# MANDATORY SERVICE BULLETIN

## SUBJECT

Nose Landing Gear (NLG) Fork Inspection.

**Figure 1-1: NGL Fork Types**

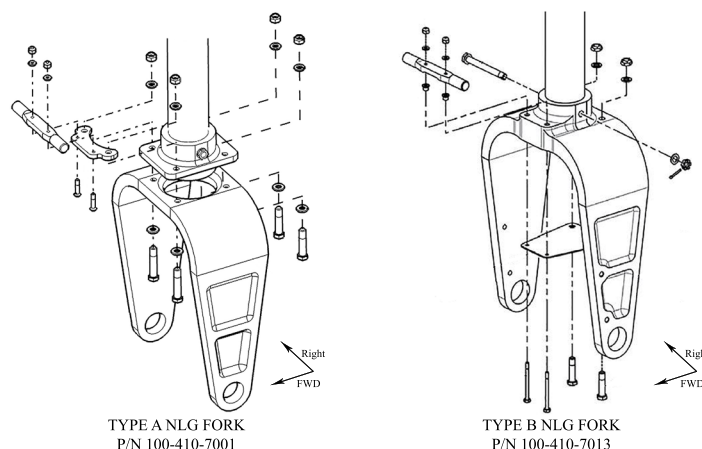
Airplane serial numbers (S/N) 100-0001 through 100-0217 were delivered with the NLG Fork P/N 100-410-7001 (identified as a “Type A” NLG Fork), and are subject to inspections per this SB. Airplanes S/N 100-0218 and subsequent were delivered with the improved NLG Fork P/N 100-410-7013 (identified as a “Type B” NLG Fork) that do not need to be inspected per this SB. Refer to **Figure 1-1**.

Kodiak has determined that it is possible for cracks to form in the Type A NLG Fork P/N 100-410-7001, when continuing to operate in conditions where a shimmy exists during the landing event, which could lead to fracture of the NLG Fork. The corresponding Field Service Instructions (FSI) provide procedures for the removal, inspection, and re-installation of the Type A NLG Fork in order to assess its current condition and determine if replacement of the NLG Fork is required.

- Remove the Type A NLG Fork and perform a non-destructive testing inspection of the NLG Fork for cracks in accordance with (IAW) **FSI-147**.
- If cracks are observed in the NLG Fork, replace the NLG Fork before further flight as outlined below:
  - For airplanes with serial numbers 100-0001 through 100-0217, replace with a serviceable Type A or Type B NLG Fork. Refer to the **AM902.0 KODIAK® 100 Airplane Maintenance Manual (AMM), Section 3222** for NLG Fork removal and installation instructions.
- If no cracks are observed in the NLG Fork, reinstall the NLG Fork and repeat the NLG Fork inspections every 200 hours TIS.

- Replacement of the Type A NLG Fork with an improved Type B NLG Fork terminates the repetitive inspections of the NLG Fork. Refer to Service Notice **SN18-01** for additional information regarding Type B NLG Forks.
